PWR Small Break LOCA Evaluation Model, S-RELAP5 Based

EMF-2328(NP)(A)
Revision 0
Supplement 1(NP)(A)
Revision 0

**SUBJECT: FINAL SAFETY EVALUATION BY THE OFFICE OF NUCLEAR REACTOR
REGULATION FOR TOPICAL REPORT EMF-2328(P)(A), REVISION 0,
SUPPLEMENT 1, REVISION 0, "PWR [PRESSURIZED WATER REACTOR]
SMALL BREAK LOCA [LOSS-OF-COOLANT ACCIDENT] EVALUATION MODEL,
S-RELAP5 BASED" (TAC NO. ME8227)**

TOPICAL REPORT EMF-2328(P)(A), REVISION 0, SUPPLEMENT 1, REVISION 0

Figure 3-5: Comparison of Primary System Mass Inventory for the L3-6 and L8-1 Tests

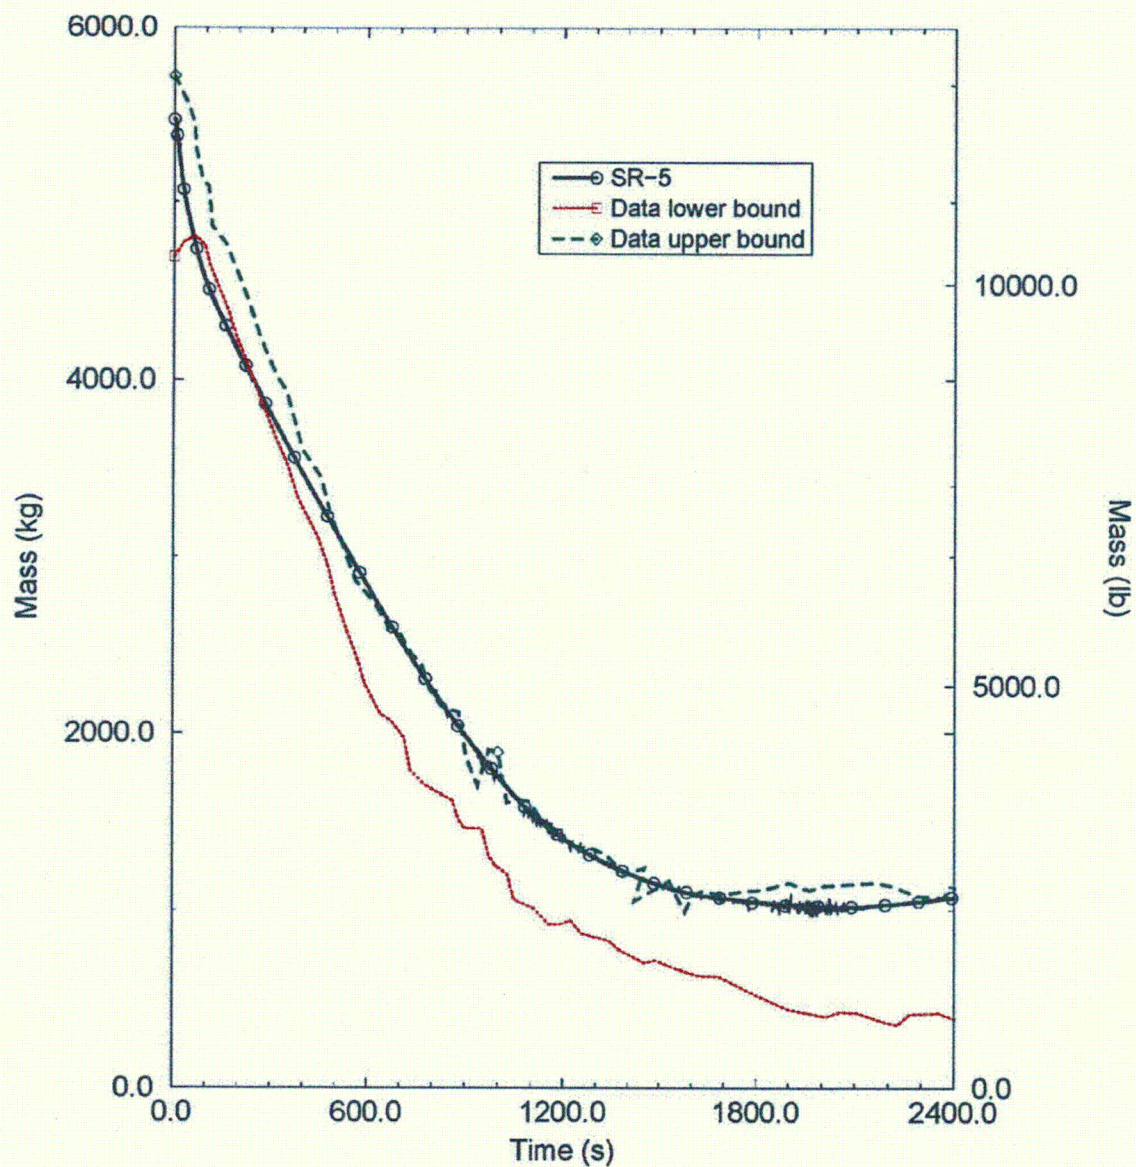
The predicted primary system mass inventory is shown in Figure 3-5 where it is compared to the lower and upper bound of the test data. The calculated primary system mass inventory remains within the bounds of the data. After 2100 seconds, the calculation shows that the HPIS flow rate slightly exceeds the break flow rate, which caused the system mass inventory to increase steadily. However, the calculated results still remained within the test data envelope. At the end of the L3-6 test, the calculated results and the upper test data converge to approximately 1100 kg.

Figure 4-2: Void Fraction in the Horizontal Part of Pump Suction Leg for Base Case

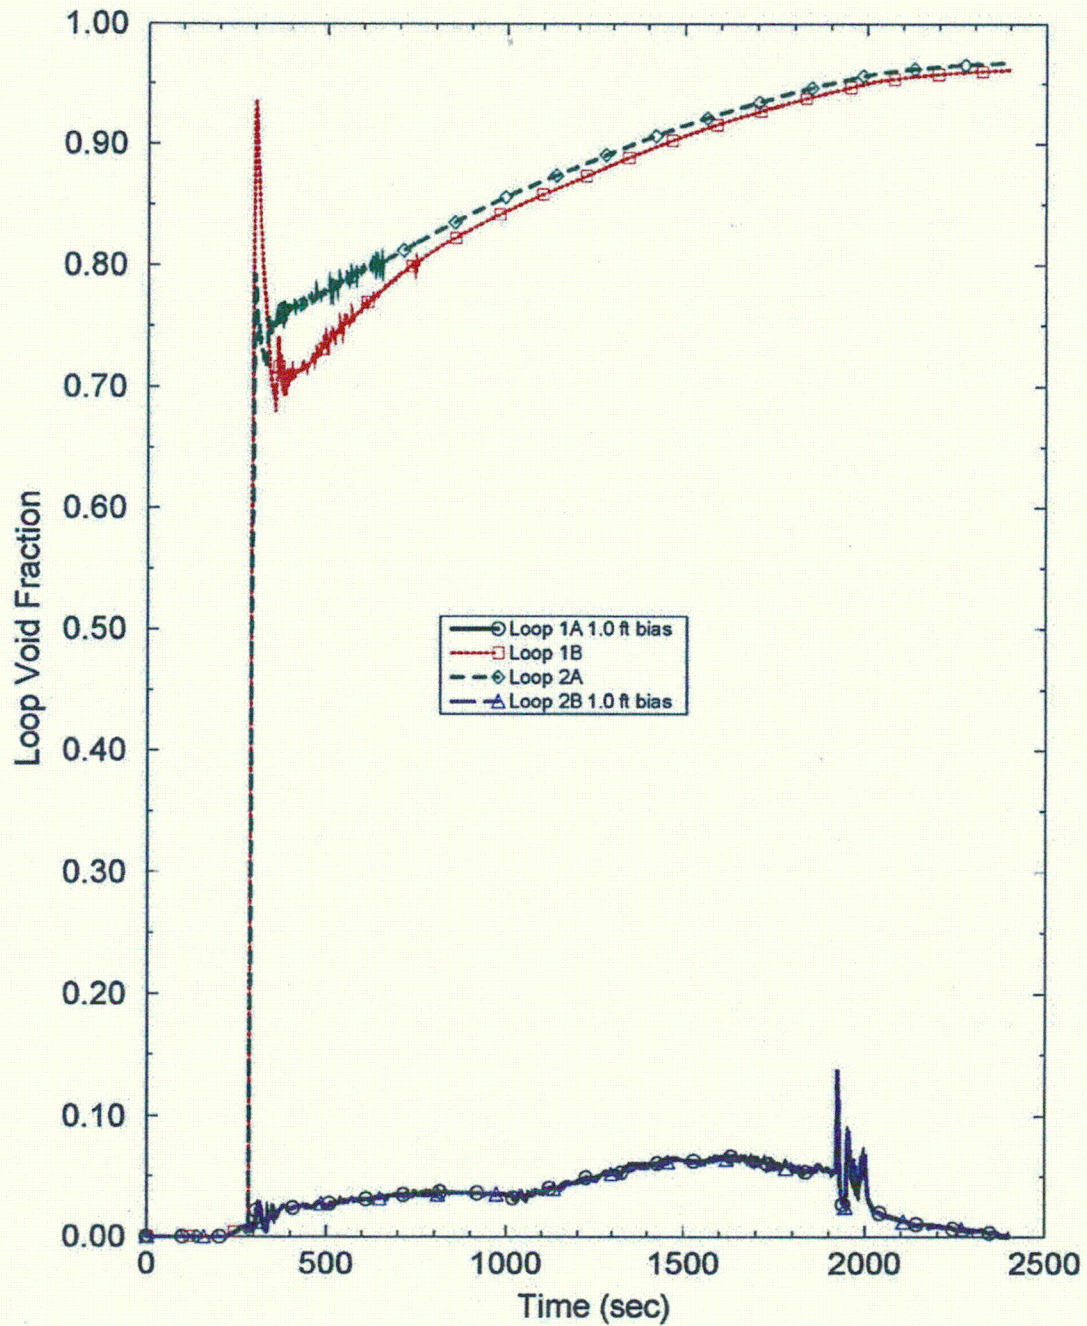
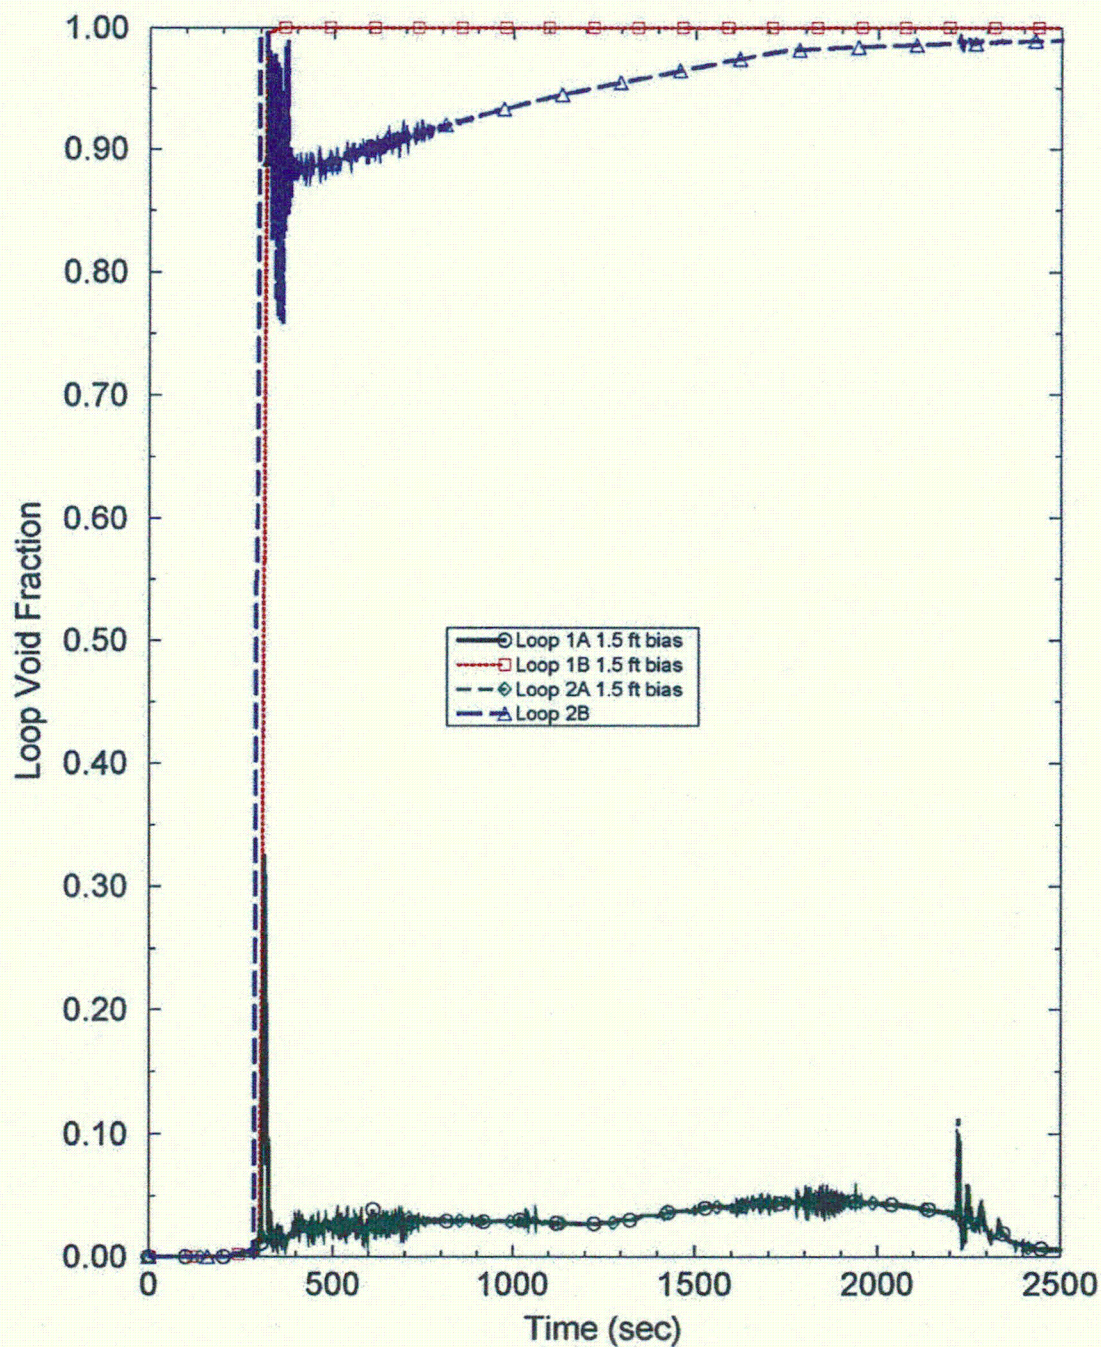
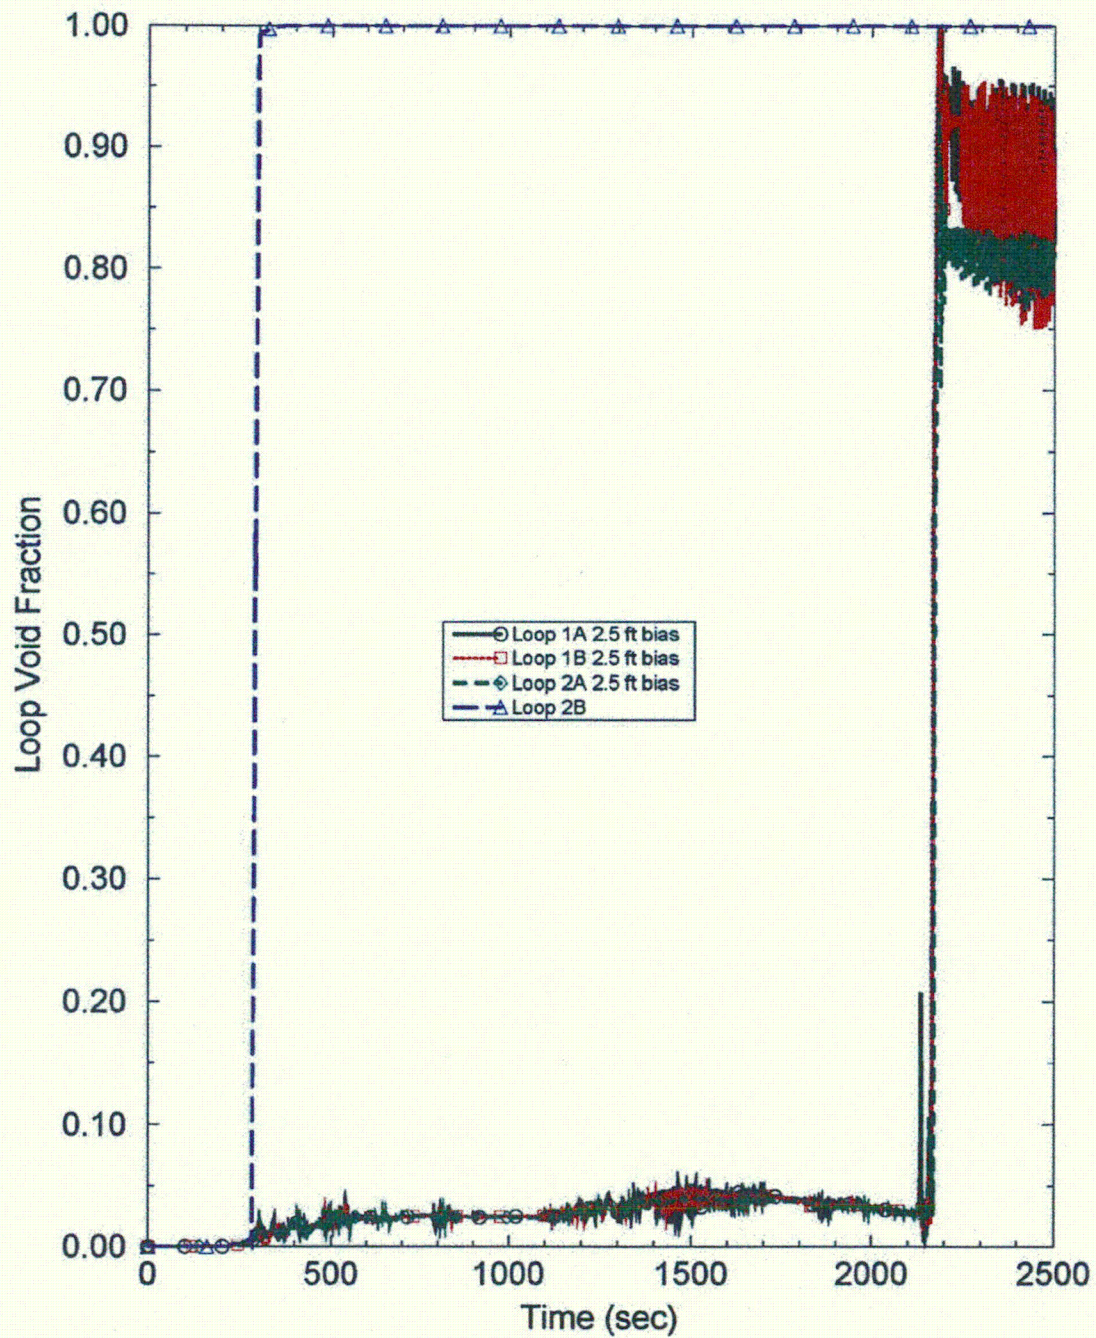
The void fraction in the horizontal part of the pump suction leg is shown in Figure 4-2, Figure 4-3, and Figure 4-4 for the *Base Case*, the *1B_2B_Clearing Case* and the *2B_Clearing Case*, respectively. Figure 4-2 shows that the intact leg 1B and 2A clear for the *Base Case*. Figure 4-3 shows that the broken leg 2B and the intact leg 1B clear for the *1B_2B_Clearing Case*. For the *2B_Clearing Case*, only the broken leg 2B clears as shown in Figure 4-4.

Figure 4-5: Integrated Break Flow Comparison Base Case/1B_2B_Clearing
Case/2B_Clearing Case

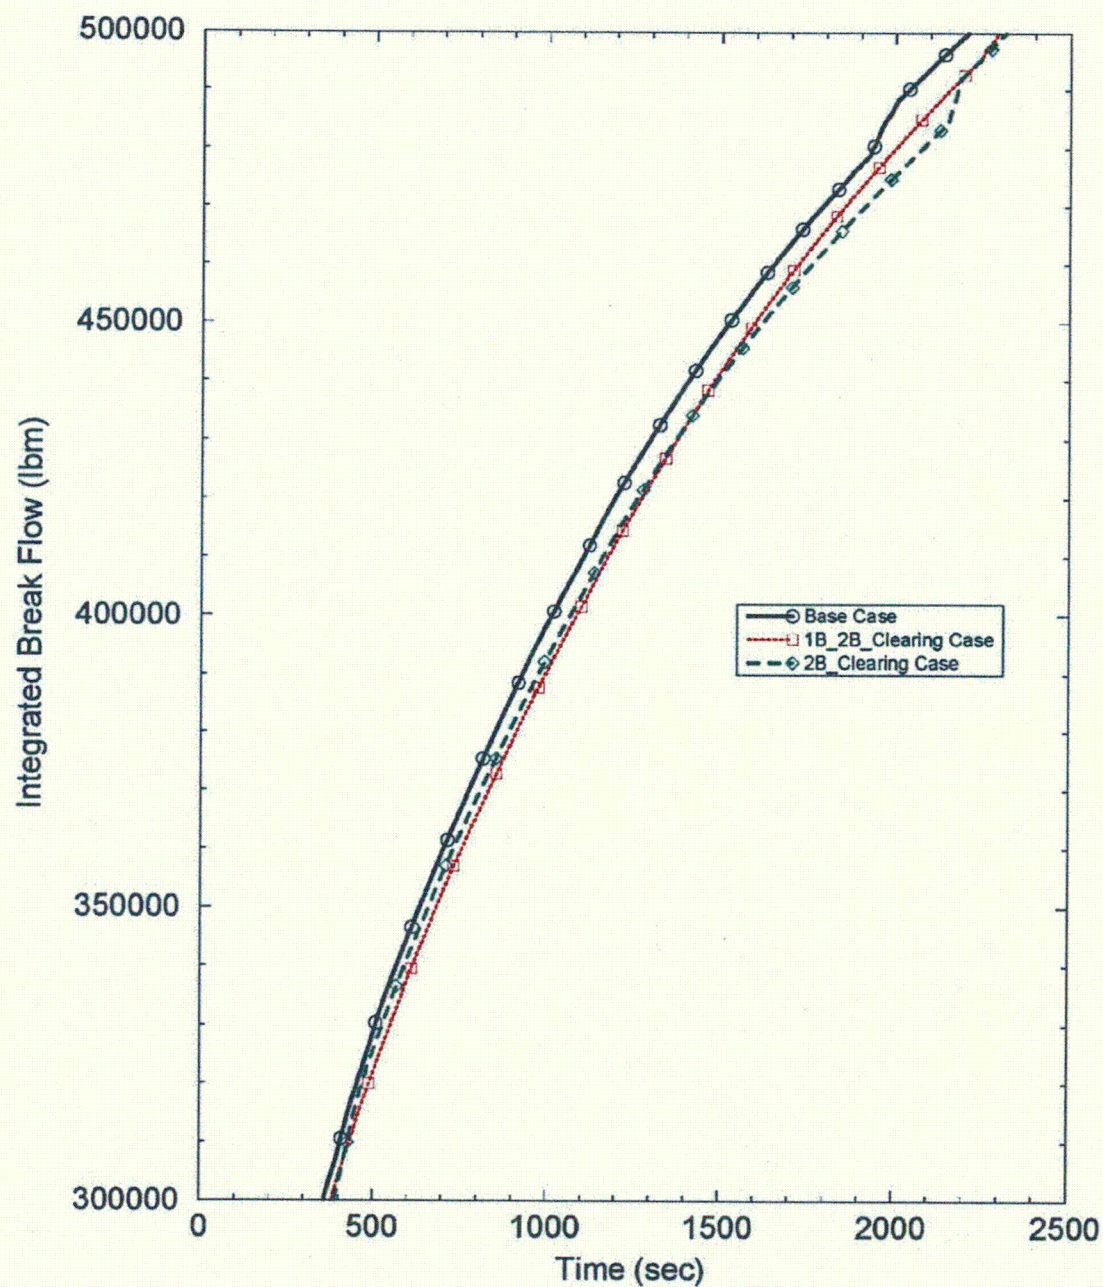
Figure 4-5 shows the integrated break flow comparison for the three cases analyzed. The inventory lost at the break is impacted by the downcomer liquid entrained by the vapor of the intact loops venting at the break. In the *Base Case*, where two intact legs (1B and 2A) are allowed to clear, a larger amount of downcomer liquid entrainment is predicted when compared to the other analyses performed. This is because all of the vapor vented at the break flows through the downcomer upper portion. For the *1B_2B_Clearing Case*, where the broken leg 2B and the intact leg 1B clear, more than half of the vapor is vented at the break through leg 2B for which downcomer liquid entrainment is limited. Therefore, the amount of downcomer liquid entrainment due to vapor from the intact loop 1B venting at the break, is reduced when compared to the *Base Case* predictions. For the *2B_Clearing Case*, where only the broken leg 2B clears, the analyses show that downcomer liquid entrainment is minimized. This behavior is shown in Figure 4-5, with the *Base Case* predicting the largest mass inventory lost at the break, followed by the *1B_2B_Clearing Case* and the *2B_Clearing Case*.

Figure 4-6: Downcomer Level Comparison Base Case/1B_2B_Clearing
Case/2B_Clearing Case

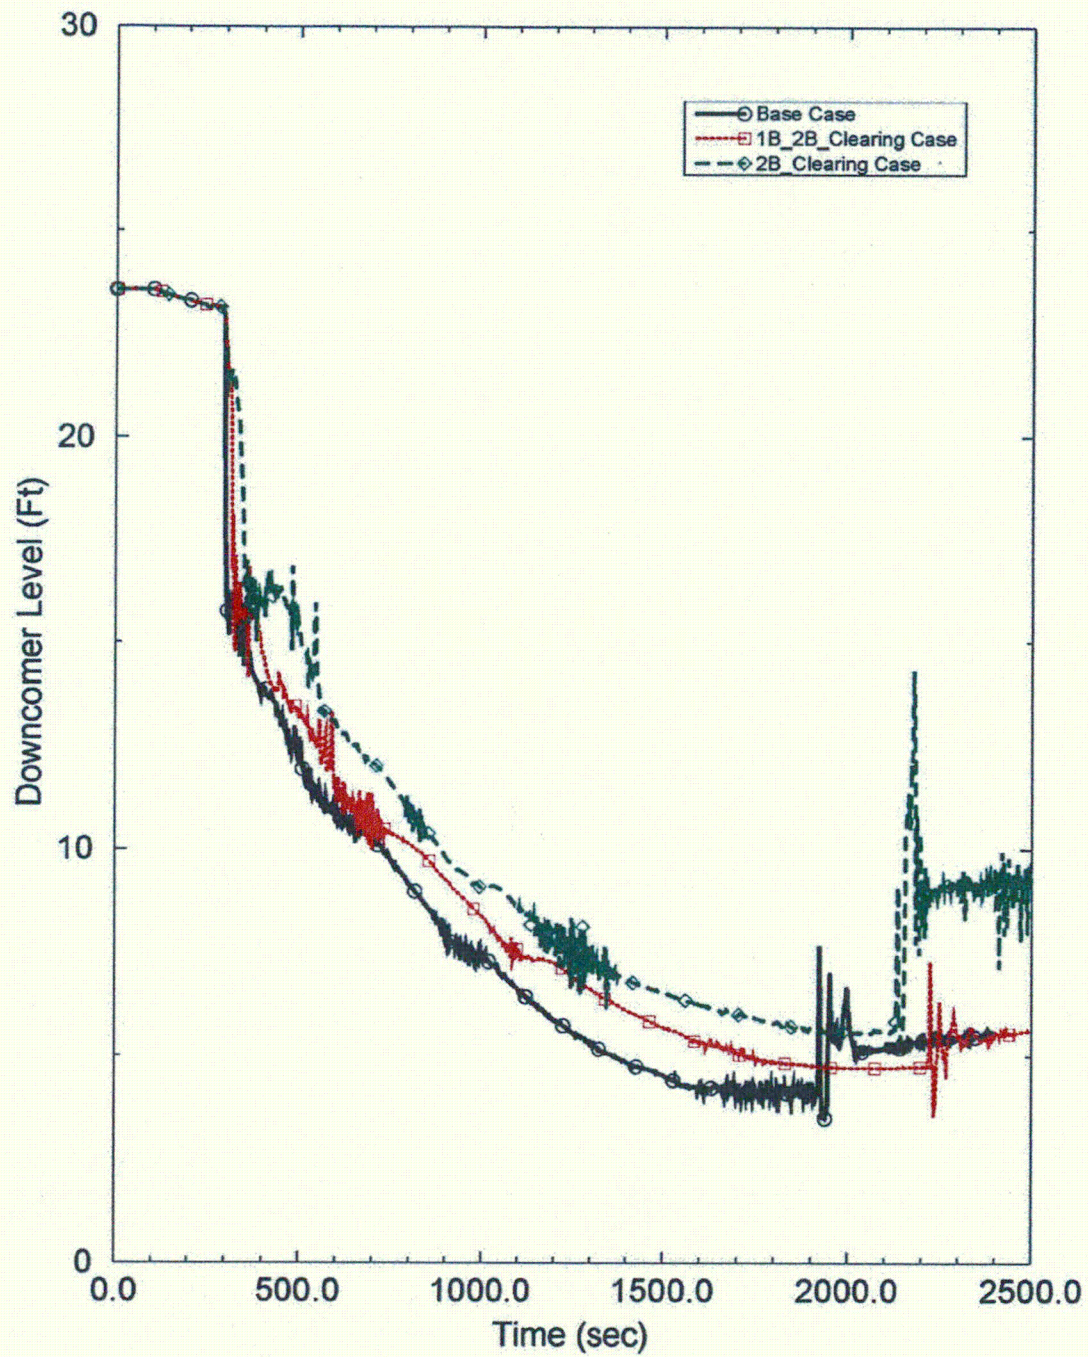
The downcomer collapsed liquid level comparison, shown in Figure 4-6, confirms the trend discussed above. Figure 4-6 also shows the effect of multiple-loop seal clearing vs. single-loop seal clearing on the vapor flow resistance for venting at the break. When vapor is venting through one loop only (*2B_Clearing Case*), the vapor flow resistance for venting at the break is larger than the case with two loop seals clearing (*1B_2B_Clearing Case*). A larger vapor flow resistance creates a larger downcomer/core hydraulic head; therefore, downcomer head is increased for the *2B_Clearing Case* when compared to the *1B_2B_Clearing Case* (Figure 4-6).

Figure 4-12: Core Collapsed Level Comparison Base Case/1B_2B_Clearing
Case/2B_Clearing Case

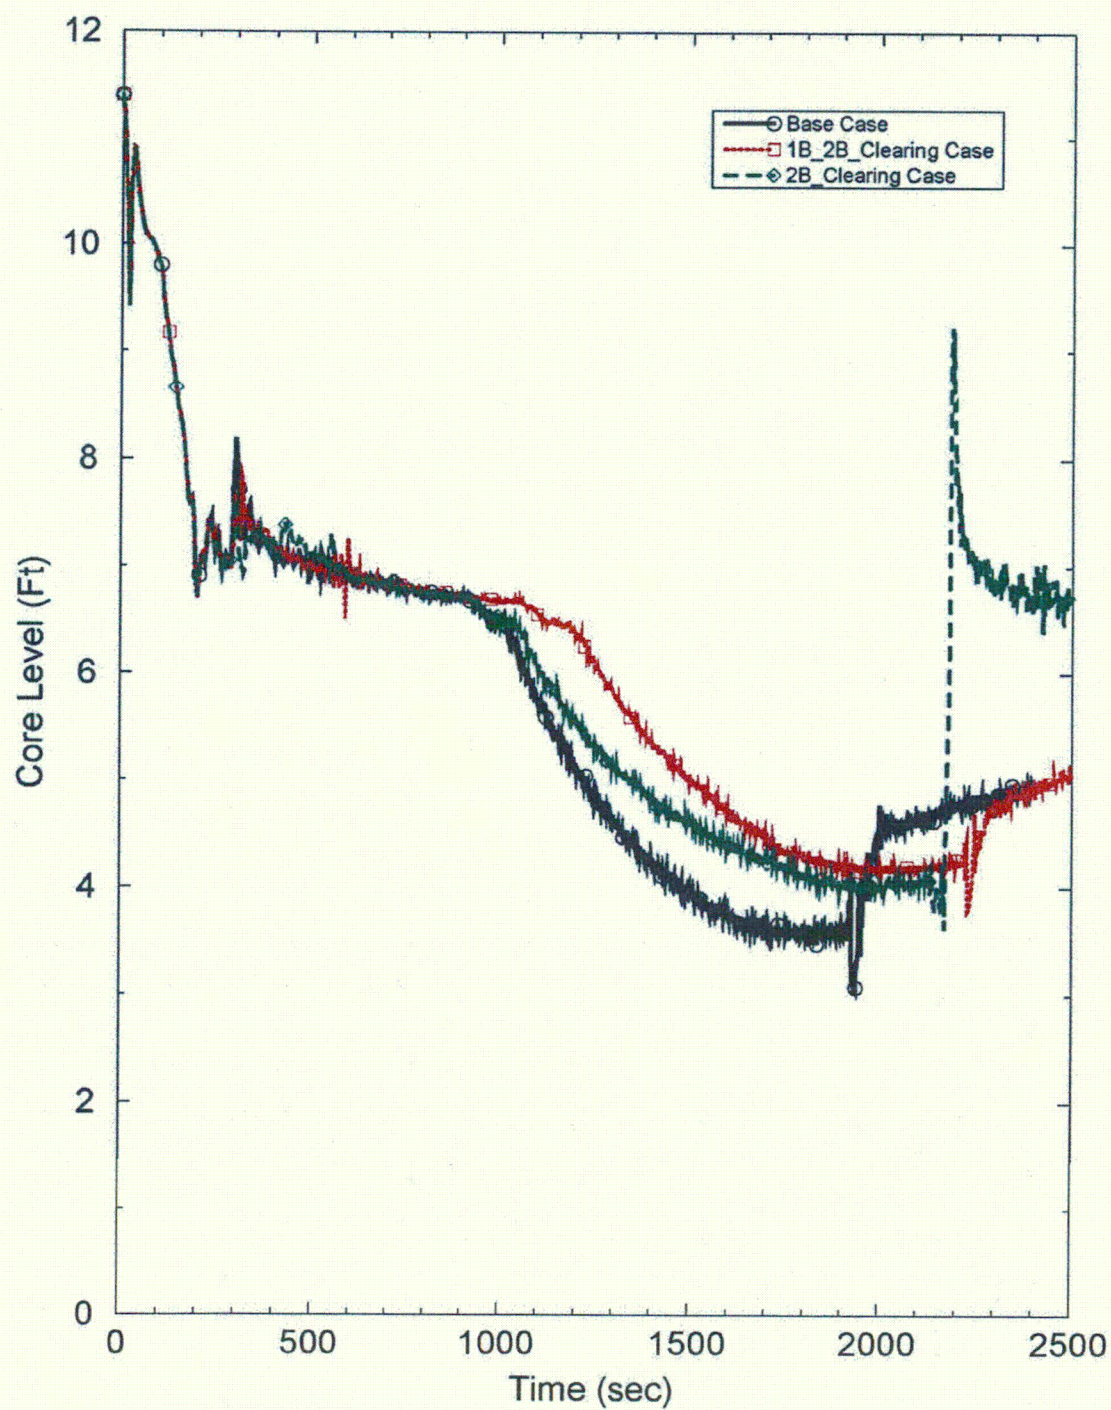
The core collapsed liquid level shown in Figure 4-12 shows that at approximately 1000 seconds, both the *Base Case* and the *2B_Clearing Case* predict core uncover. Core uncover is reached for the *1B_2B_Clearing Case* with a 200 second delay due to the combined effect of venting vapor at the break through multiple loops and a larger inventory of coolant draining from the upper plenum.
